[Docket No. FAA-2009-0514; Airspace Docket No. 07-AWA-1]

Amendment to Class B Airspace; Cleveland, OH

ACTION: Final rule.

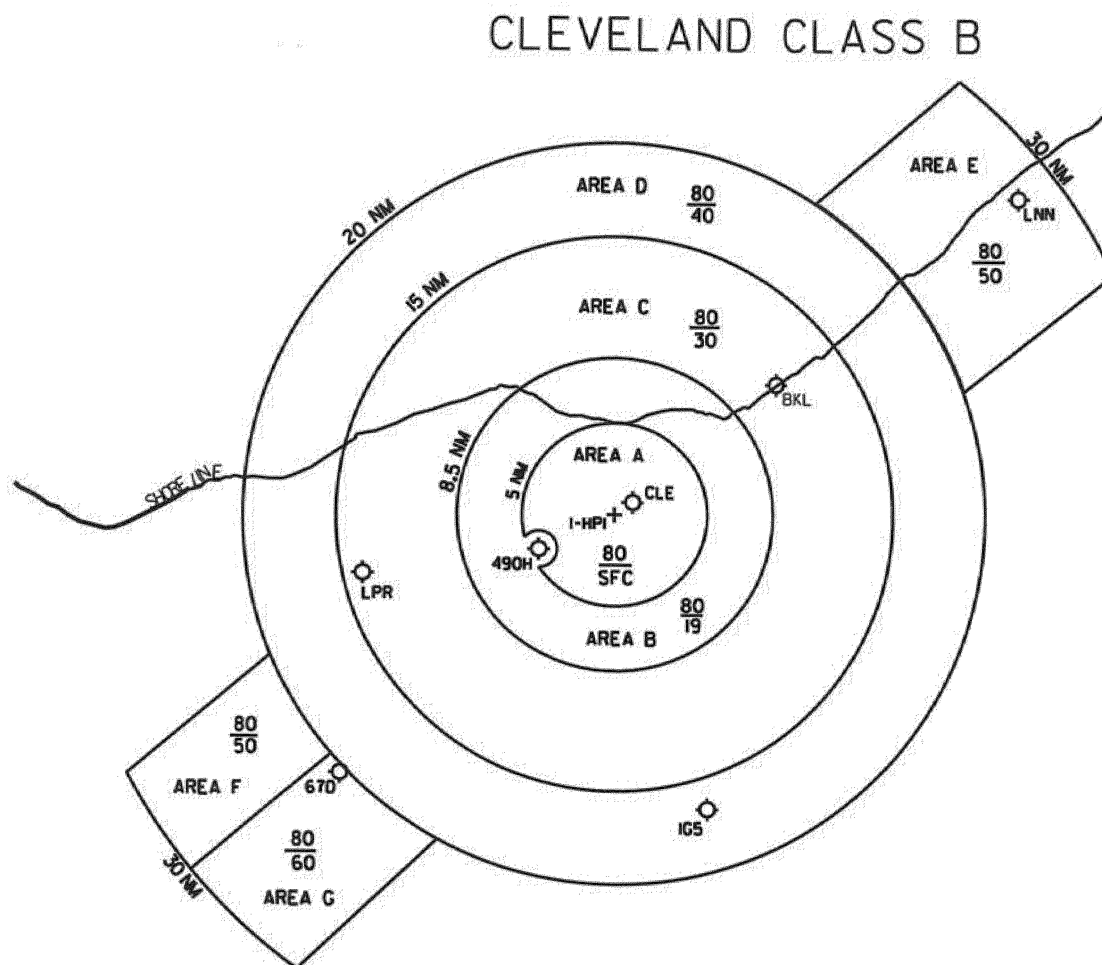
Seven commenters objected to proposed Areas F and G. They argued the FAA proposed these areas significantly larger than required or presented previously. Six of the commenters wanted the lateral dimensions of the areas reduced to only five nautical mile (NM) extensions in length by five NM in width. One commenter argued that federal airways are established with four NM lateral widths from a radial of a navigation aid and that the FAA should reduce the widths of the areas to four NM also. Three commenters wanted Areas F and

G eliminated altogether if the lateral dimensions could not be reduced. And lastly, three commenters suggested the FAA define the boundaries of Areas F and G to coincide with visual landmarks to prevent inadvertent Class B airspace violations. Unless changed, the commenters believed the proposed Areas F and G would deteriorate safe flight operations beneath and in the vicinity of the Class B airspace extension.

Eight commenters suggested the split floor altitudes proposed for Areas F and G (5,000 feet mean sea level (MSL) and 6,000 feet MSL, respectively) would cause confusion and probably some inadvertent Class B airspace incursions. The commenters stated the split level proposed design still presented a safety infringement to the glider operations at Reader-Botsford airport (67D) and offered multiple recommendations for changing the floor altitudes to remedy their concerns. Two commenters recommended raising the floor of Areas F and G to 6,000 feet MSL and 7,000 feet MSL, respectively; two commenters recommended making both floor altitudes 6,000 feet MSL; and three commenters recommended raising the Area G floor only to 7,000 feet MSL.

Eleven commenters stated that establishing the proposed Areas F and G extension would adversely affect flight safety beneath and in the near vicinity of the extension. The safety concerns cited included compression of general aviation aircraft under the extension where gliders operate, increased potential for mid-air collisions, wake turbulence effects on gliders from heavy aircraft arrivals on approach to CLE, and increased potential for off-field landings by glider pilots as a result of the extension overhead 67D.

Three commenters stated that the geographic coordinates [latitude/longitude] defining Areas F and G did not coincide with the text of the NPRM and needed to be redefined consistent with the dimensions briefed at the informal airspace meetings. Two of these commenters further noted that the southern boundary of Area G was not parallel with the Runway 6R centerline extended as proof the coordinates were in error.

The FAA does not agree. For clarity, the lateral dimensions of Areas F and G as proposed in the NPRM are 10 NM in length, extending from the CLE Runway 24L ILS/DME antenna (I-HPI) 20 NM arc to the I-HPI 30 NM arc. The areas are 6 NM in width, from the CLE Runway 6R localizer (I-CLE) signal extended to 6 NM north of the Runway 6L localizer (I-LIZ) signal extended for Area F and from the I-CLE signal extended to 6 NM south of the Runway 6R localizer (I-EYU) signal extended for Area G. These lateral dimensions were determined to be the absolute minimum essential to control IFR aircraft arriving from multiple arrival streams that are being sequenced in the traffic patterns for Precision Runway Monitor/Simultaneous Offset Instrument Approaches (PRM/SOIA) procedures into CLE. The length of these areas ensures the 15 to 18 percent of IFR aircraft arrivals that currently enter, exit, and re-enter the CLE Class B airspace (as noted in the NPRM) are fully contained within Class B airspace once they enter the traffic patterns to intercept the final approach course and the PRM/SOIA procedures. During periods of moderate and heavy traffic, aircraft may be turned onto the PRM/SOIA finals as far as 25 NM to 30 NM from CLE, as is the case today. The width of these areas ensures IFR arrival aircraft conducting PRM/SOIA are contained within Class B airspace while flying in the traffic patterns and are safely separated, in accordance with aircraft separation standards and guidance, between non-participating VFR aircraft that may be flying along the boundaries of Areas F and G and IFR aircraft flying the instrument approach procedures to Runways 6L/6R. To reduce the lateral dimensions (length or width) of the Areas F or G Class B airspace extensions would be impractical.

The FAA does not agree and has determined it is not possible to raise the floor altitude of either area without impacting the operational efficiency of the PRM/SOIA into CLE. Again, for clarity, the vertical dimensions of Areas F and G as proposed in the NPRM are from 5,000 feet MSL to and including 8,000 feet MSL for Area F and from 6,000 feet MSL to and including 8,000 feet MSL for Area G. Initially, the Class B airspace extension to the southwest in the same airspace proposed as Areas F and G was designed as a single area with a floor altitude of 5,000 feet MSL. After receiving public input from the ad hoc committee and public comments following the informal airspace meetings recommending the configuration proposed, the subdivision and altitudes of the two areas were proposed using the minimum amount of airspace necessary to contain PRM/SOIA procedures to Runways 6L/6R at CLE.

The FAA does not agree. The coordinates published in the NPRM regulatory text for defining Areas F and G were validated with the FAA's Aeronautical Navigation Procedures Group and found to be correct and consistent with the text published in the NPRM. The FAA acknowledges that

Areas F and G proposed in the NPRM differ from what was presented during the informal airspace meetings. However, the proposed Areas F and G airspace published in the NPRM is the minimum necessary to reasonably contain IFR arrival aircraft flying PRM/SOIA procedures to runways 6L and 6R, and the geographic coordinates published accurately reflect these areas. With respect to the comments about the southern boundary of Area G, the commenters are correct that the boundary is not parallel to the runway 6R centerline extended. The northern and southern boundaries of the Area G are defined from different navigation aids. The northern boundary is defined by the Runway 6R localizer (I-CLE) signal extended, and the southern boundary is defined 6 miles south and parallel to the Runway 6R localizer (I-EYU) signal extended. This accounts for the fact that the southern boundary of Area G is offset by 3 degrees and is not parallel to the northern boundary.
